Planning Commission Staff Report

Subject: Marsac Avenue Affordable Housing
Author: Brooks T. Robinson
Date: July 9, 2008
Type of Item: Administrative – Master Planned Development

Applicant: United Park City Mines Company
Location: 100 Marsac Avenue
Zoning: Historic Residential (HR-1)
Adjacent Land Uses: State Route 224 to west, residential zones to east and north, open space to south.
Reason for Review: Master Planned Developments require Planning Commission review

Exhibit A – Site plan

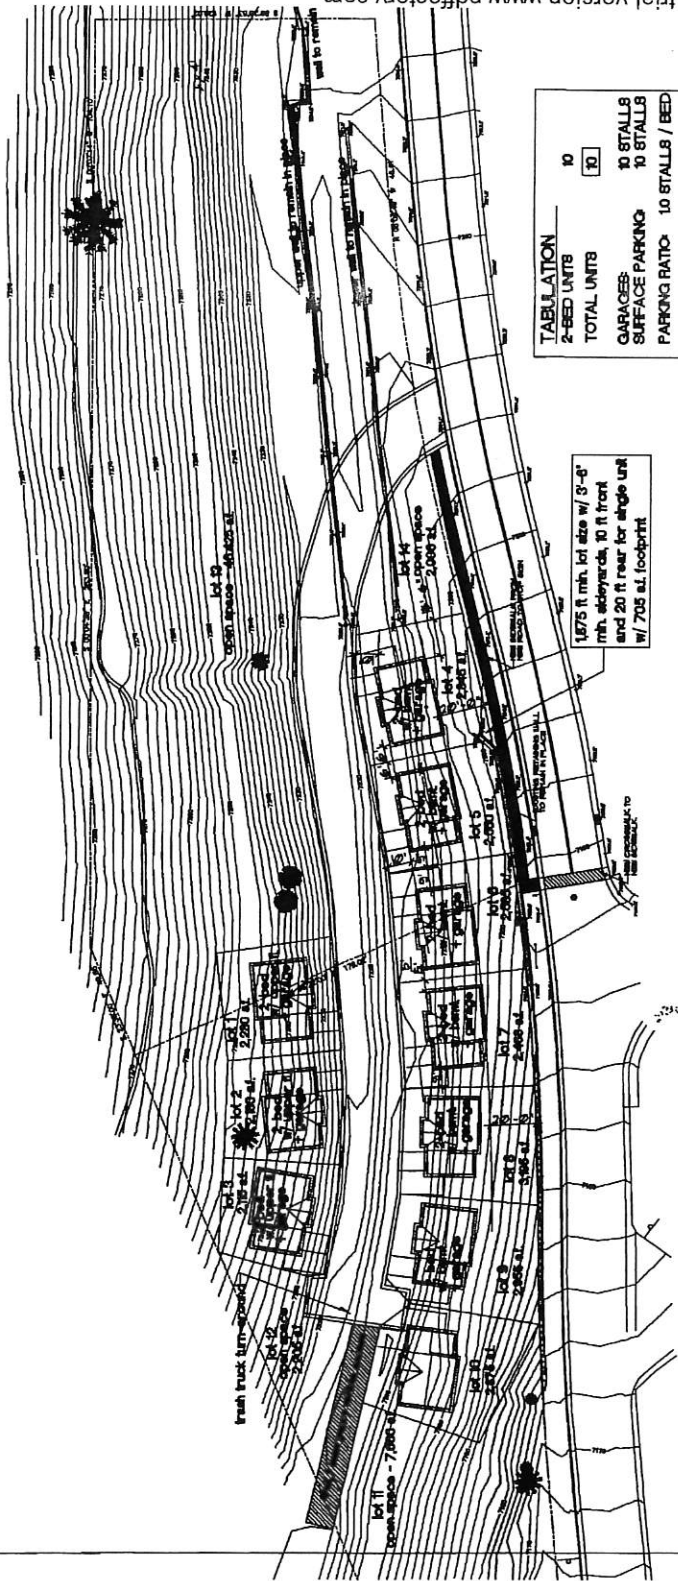
The Planning Commission can reduce this requirement to the underlying HR-1 zone setbacks. The proposed plan shows a setback of 20 feet for the rear of the downhill (west) units due to the narrow site constraints. Staff recommends that the HR-1 zone setbacks be applied.

The access road generally follows the old railroad grade. Seven of the stand alone houses back towards Marsac Avenue with three of the units on the uphill side. A primary consideration in the design is the preservation of approximately 80% of the stone retaining walls. The plan identifies 1.34 acres of dedicated open space.

No sidewalk is provided within the project. A sidewalk is proposed along a portion of Marsac Avenue with a crosswalk at the Marsac/Hillside intersection. The emergency access/trail would connect to Ontario Court. There is a turnaround for fire trucks or garbage collection vehicles at the end of the access driveway.

There are sufficient areas for snow storage along the access driveway and the south end.
